W3F1-2000-0086
A4.05
PR

Subject: Waterford 3 SES
Docket No. 50-382
License No. NPF-38
Technical Specification Change Request NPF-38-226
Response to Request for Additional Information Regarding
Containment Building Penetrations

**Response to Request for Additional Information
Technical Specification Change NPF-38-226
Containment Building Penetrations during Core Alterations and Fuel Movement**

Site Photograph

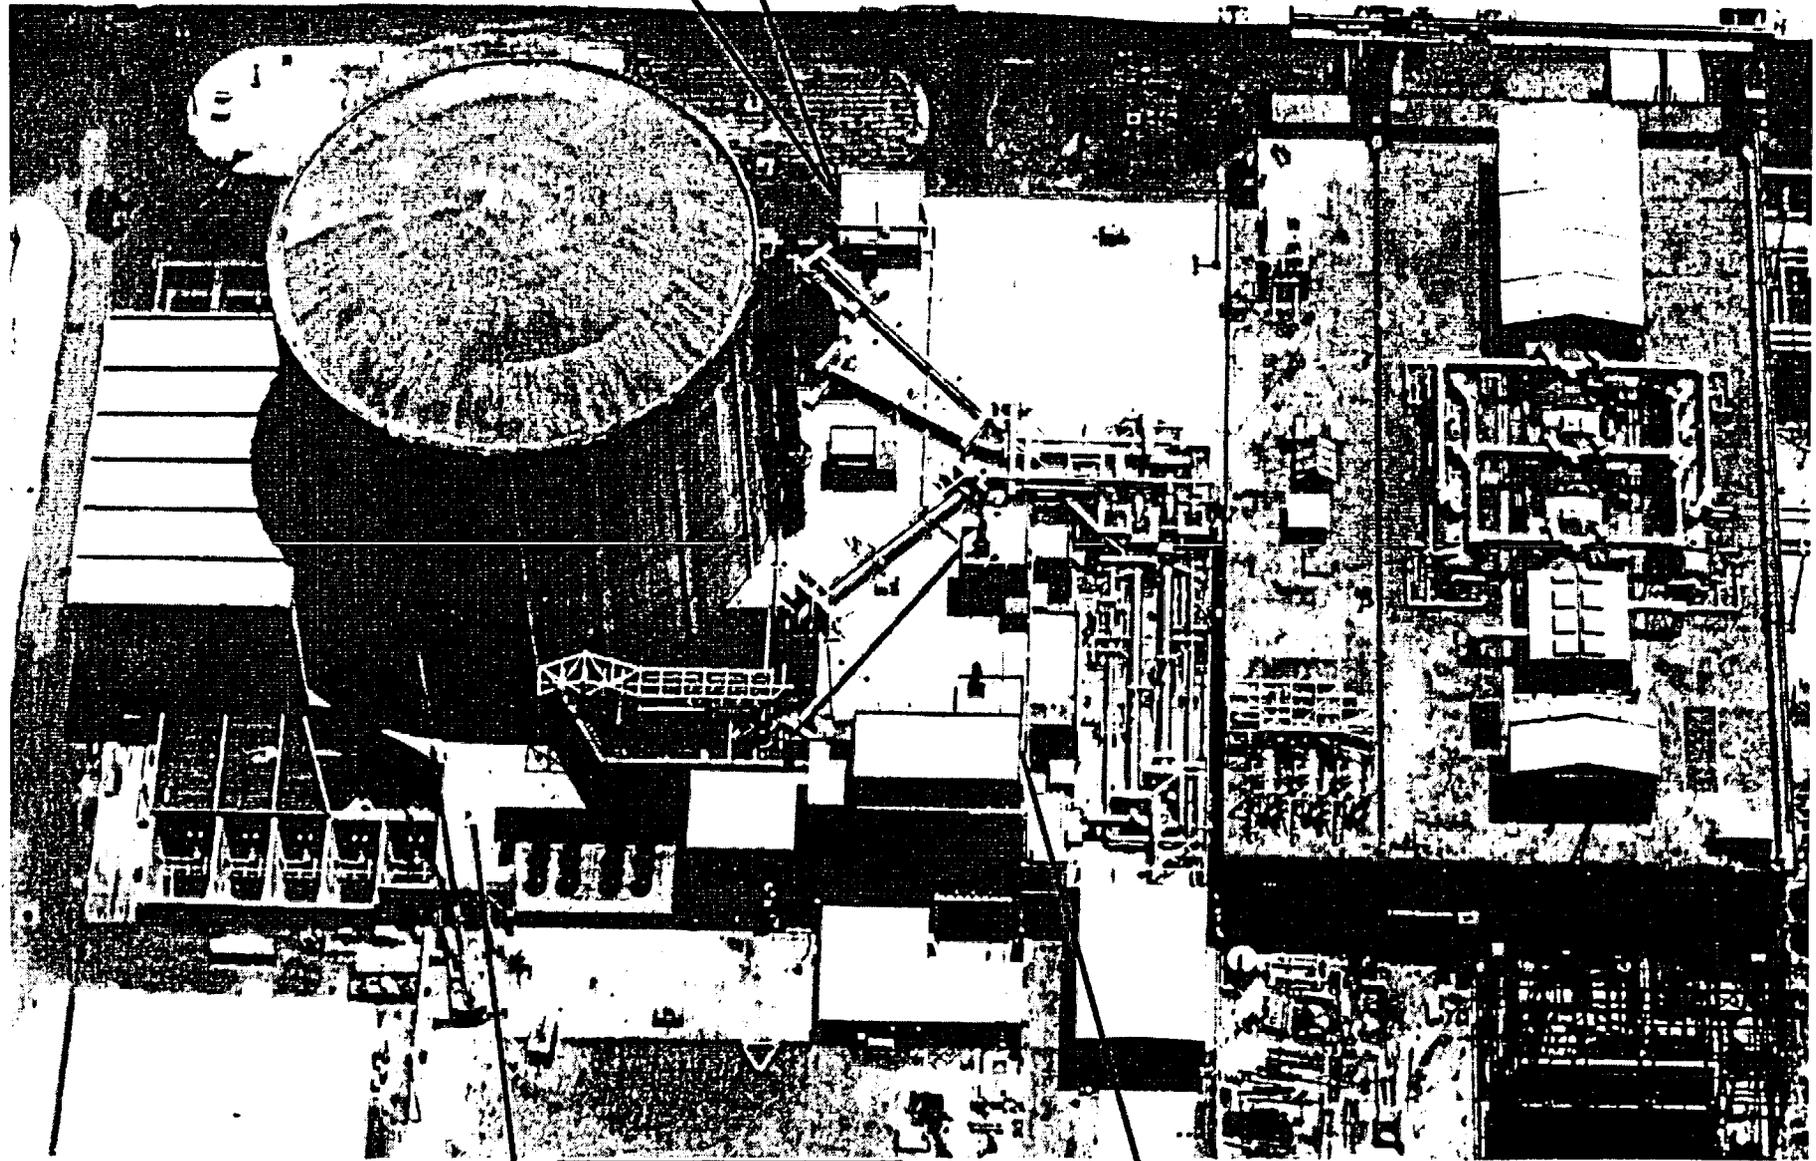
Please provide information on the locations of the control room intakes, equipment hatch, and any other release paths for the fuel handling accident inside containment as proposed in the submittal. Include a diagram or site plan of the Waterford Steam Electric Station, Unit 3 site indicating the locations of the control room, control room intakes, equipment hatch, and intervening buildings.

Attachment 2 provides a site photo with hatch locations and outside air intakes noted. In addition, site general arrangement drawings in the UFSAR provide additional clarification of the relative locations of these areas. In particular, UFSAR Figures 1.2-8 (now in the reference drawing section of the last UFSAR volume), 1.2-18, and 1.2-19 provide information on the hatches, personnel air locks, and intakes of interest.

The equipment hatch is located at approximately azimuth 278° and a centerline elevation of 26.5' (see UFSAR Figure 1.2-18). The personnel airlock is at approximately azimuth 172° and a centerline elevation of 11' (see UFSAR Figure 1.2-19). The emergency airlock is located at approximately azimuth 322° and a centerline elevation of 25' (see UFSAR Figure 1.2-18).

The normal control room outside air intakes and north emergency outside air intakes are located on the outside north facing wall at approximately elevation 73'. The south emergency air intakes are located on a south facing wall at approximately elevation 75'.
